Access Compliance Report

Public Rights-of-Way

(Curb Ramps)

Intersection ID: 29416	Main Street: PADDARBORN_CT	Cross Street: SALINGER_WY	Location: W
ADA ID: F5FAFE36E595	Ramp Type: Perp	Initial Pass/Fail: Fail	Overall Compliance: No
Severity Score: 13.75			
Codes/Mitigation Info/Possible Solution		Field Measurements/Component Compliance

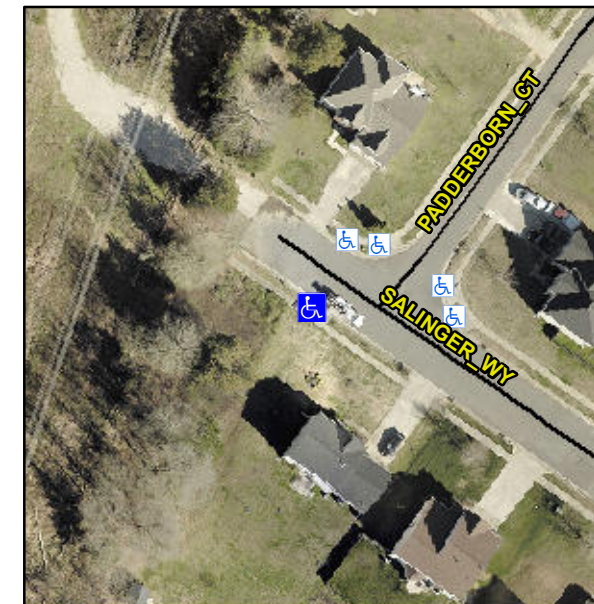
Not Found, R304.2.2, R304.5.3

Compliance	Description	Data	Compliance	Description	Data
N/A	Ramp Length (in)	49.5	No	Ramp Slope (%)	11.9
Yes	Ramp Width (in)	48.0	No	Ramp XSlope (%)	3.5
N/A	Flare Type LT	N/A	N/A	Flare Type RT	N/A
N/A	Flare Slope LT (%)	N/A	N/A	Flare Slope RT (%)	N/A
N/A	Flare Traversable LT?	N/A	N/A	Flare Traversable RT?	N/A
N/A	Landing Length (in)	N/A	N/A	DWS Provided?	N/A
N/A	Landing Width (in)	N/A	N/A	DWS Contrast?	N/A
N/A	Landing Slope (%)	N/A	N/A	DWS Length (in)	N/A
N/A	Landing X Slope (%)	N/A	N/A	DWS Full Width?	N/A
N/A	Landing Curb? (Y/N)	N/A	N/A	DWS Offset (in)	N/A
N/A	Shared Landing?	N/A			
N/A	Gutter Ponding?	N/A	N/A	Gutter Slope (%)	N/A
N/A	Gutter Lip Ht (in)	N/A	N/A	Gutter X Slope (%)	N/A
N/A	Painted X Walk1?	No	N/A	Painted X Walk2?	N/A
	X Walk 1 Direction	To NE		X Walk 2 Direction	N/A
N/A	X Walk 1 Width (in)	N/A	N/A	X Walk 2 Width (in)	N/A
	X Walk 1 Slope (%)	3.3		X Walk 2 Slope (%)	N/A
	X Walk 1 X Slope (%)	2.1		X Walk 2 X Slope (%)	N/A

Remove & Replace Entire Ramp.
